# Access Compliance Report

## Public Rights-of-Way

### (Curb Ramps)

Intersection ID: 4392	Main Street: HATWYNN_RD	Cross Street: MALLARD_GROVE_RD	Location: W
ADA ID: 58E6D37C80CB	Ramp Type: Directional1	Initial Pass/Fail: Fail	Overall Compliance: No
			Severity Score: 33.75

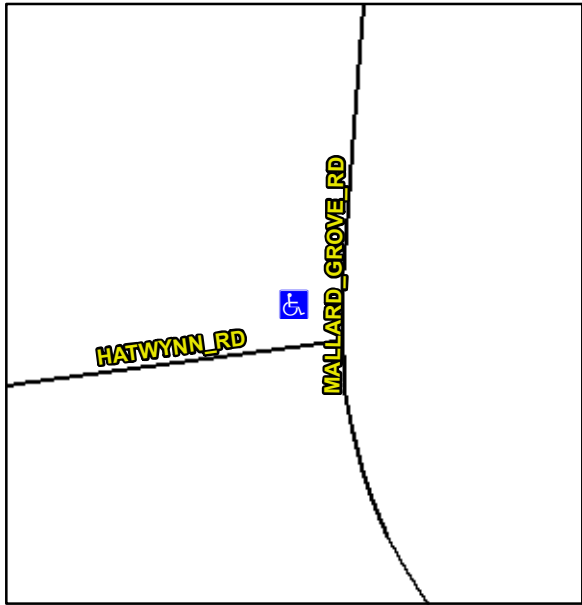
Codes/Mitigation Info/Possible Solution			Field Measurements/Component Compliance					
	Possible Solutions:		Compliance	Description	Data	Compliance	Description	Data
	Remove & Replace Entire Ramp.		N/A	Ramp Length (in)	81.0	N/A	Grade Break?	N/A
			No	Ramp Width (in)	47.0	N/A	Grade Break Slope (%)	0.0
			No	Ramp Slope (%)	15.5	N/A	Grade Break XSlope (%)	0.0
			Yes	Ramp XSlope (%)	1.8			
			N/A	Flare Type LT	N/A	N/A	Flare Type RT	N/A
			N/A	Flare Slope LT (%)	N/A	N/A	Flare Slope RT (%)	0.0
			N/A	Flare Traversable LT?	N/A	N/A	Flare Traversable RT?	N/A
			N/A	Landing Length (in)	0.0	N/A	DWS Provided?	N/A
			N/A	Landing Width (in)	0.0	N/A	DWS Contrast?	N/A
Surveyor Notes:		N/A	N/A	Landing Slope (%)	0.0	N/A	DWS Length (in)	N/A
PROW/ADA:		R304.5.1, R304.2.2	N/A	Landing X Slope (%)	0.0	N/A	DWS Full Width?	N/A
			N/A	Landing Curb? (Y/N)	N/A	N/A	DWS Offset LT (in)	N/A
			N/A	Shared Landing?	N/A	N/A	DWS Offset RT (in)	N/A

N/A	Gutter Ponding?	0.0	N/A	Gutter Slope (%)	N/A
			N/A	Gutter Lip Ht (in)	0.0	N/A	Gutter X Slope (%)	N/A
			N/A	Painted X Walk1?	No		Road Slope (%)	3.9
				X Walk 1 Direction	To S		Road X Slope (%)	8.6
				X Walk 1 Width (in)	N/A		Clear Space?	N/A
				X Walk 1 Slope (%)	3.9	N/A	Clear Space to XWalk (in)	N/A
				X Walk 1 X Slope (%)	8.6	N/A	Storm Grate/Utility Hazard?	N/A
			N/A	Ramp inside XWalk1?	N/A		Storm Grate/Utility Type	
			N/A	Any Obstructions?	N/A			N/A
				Obstruction Type		Yes	Surface Condition? (G/P)	Good
					N/A	N/A	Curb Slope (%)	N/A
Street 1 Name		HATWYNN RD						
Stop Condition-Street 1		StopSign						
Street 2 Name		N/A						
Stop Condition-Street 2		N/A						
Total Cost:		\$ 1600.00

R304.5.1, R304.2.2

Remove & Replace Entire Ramp.
